Europe/Middle East**Bulletin N°:****KDM 48/22****Product Support Program: Mandatory****Section:****Engine****Date of completion: April 30, 2024****Issue:****Revision A****Date:****April / 2023**

PSP 202259 - Retrofit the turbocharger support bracket conversion kit

Fig. 1

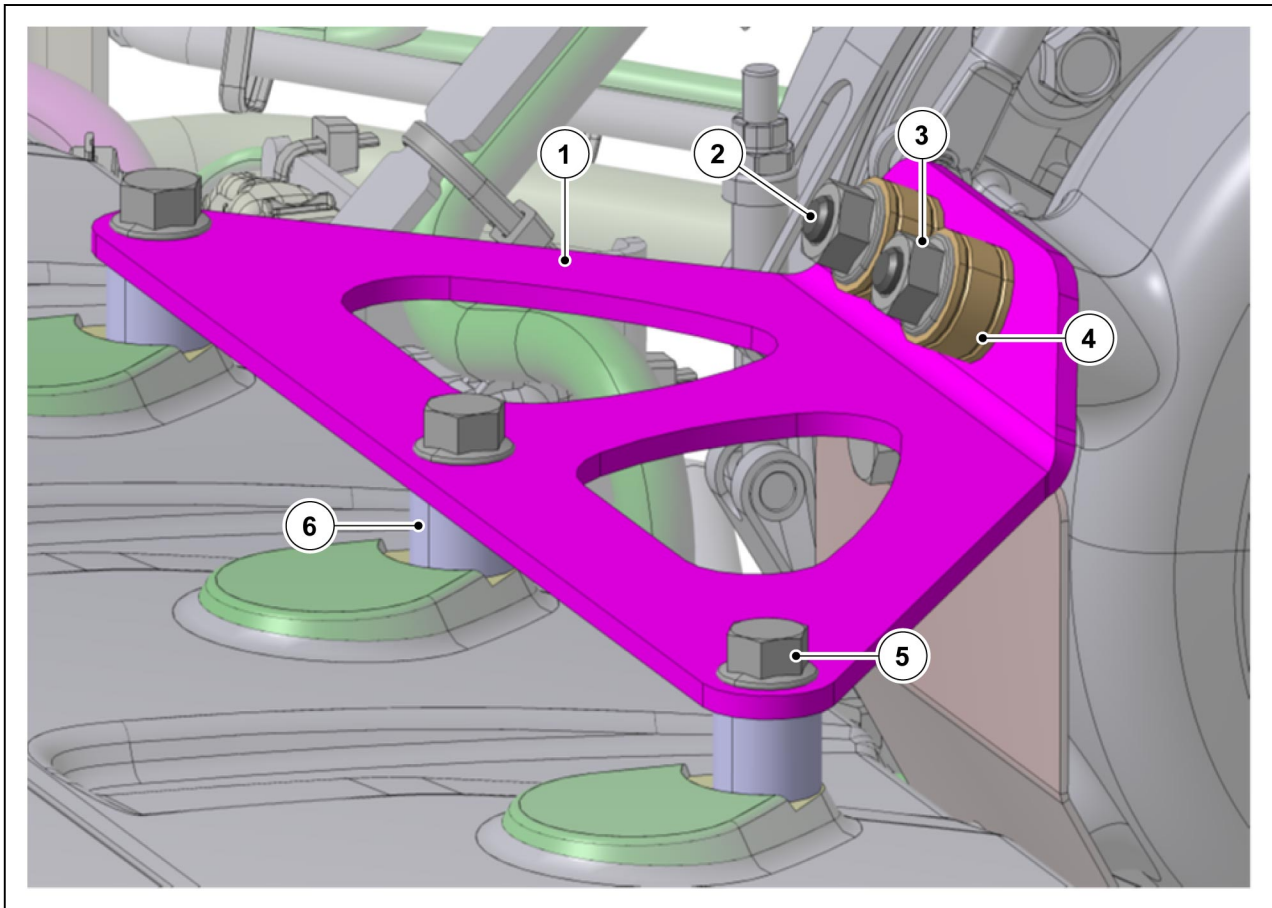
Increased vibrations can cause the turbocharger fasteners to break.

Install the support bracket conversion kit U972200100000 as shown in (Fig.1).

Support bracket conversion kit U972200100000 contains the following parts.

Item Number	Description	Part Number	Quantity	Torque
1	Support Bracket	ACP0708070	1	-
2	Stud	ACP0708080	2	24 Nm
3	Nut	F530200090740	2	30 Nm
4	High temperature bushing	ACP0708090	2	-
5	Bolt	H218PF150235A	3	30 Nm
6	Spacer	ACP0353760	3	-

1. If equipped, remove the air accumulator, access through the left side of the machine.
2. Remove the paint from the contact points.
3. Clean and re-cut the threads if necessary.
4. Install the support bracket conversion kit as shown in (Fig.1). Torque values can be found in the table above.

Fig. 2

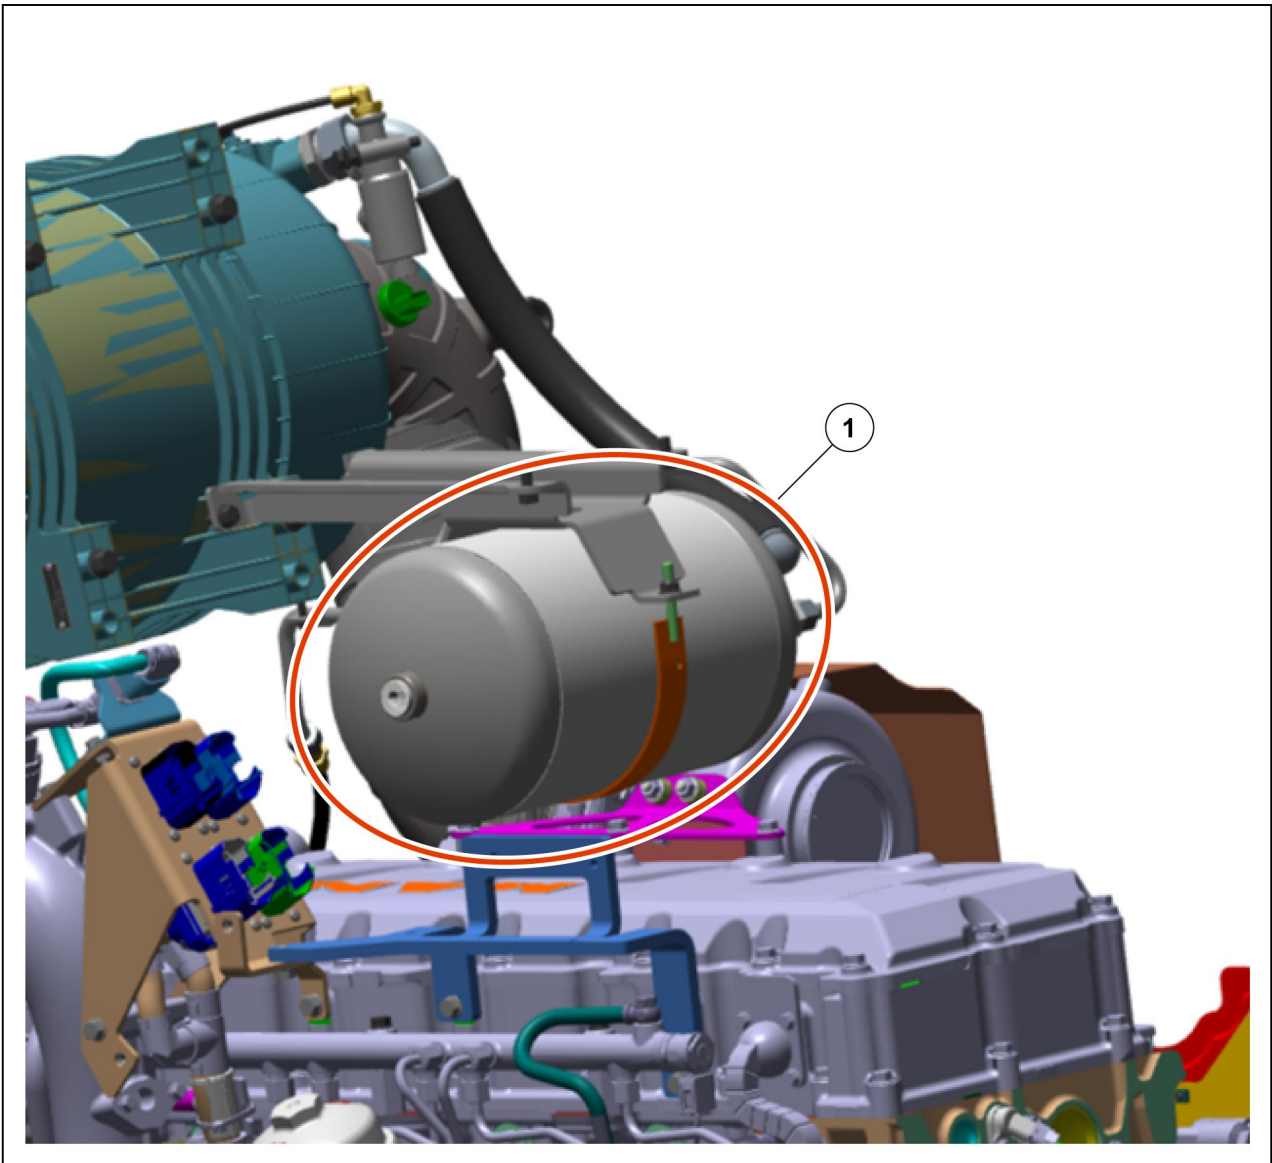
NOTE: For machines equipped with self-cleaning air filters, an additional 0.5 hour labor time is permitted. These machines can be recognised by the air accumulator (1) above the valve cover as shown in (Fig. 2).

The pressure inside the air accumulator must be completely discharged before the air hoses are disconnected.
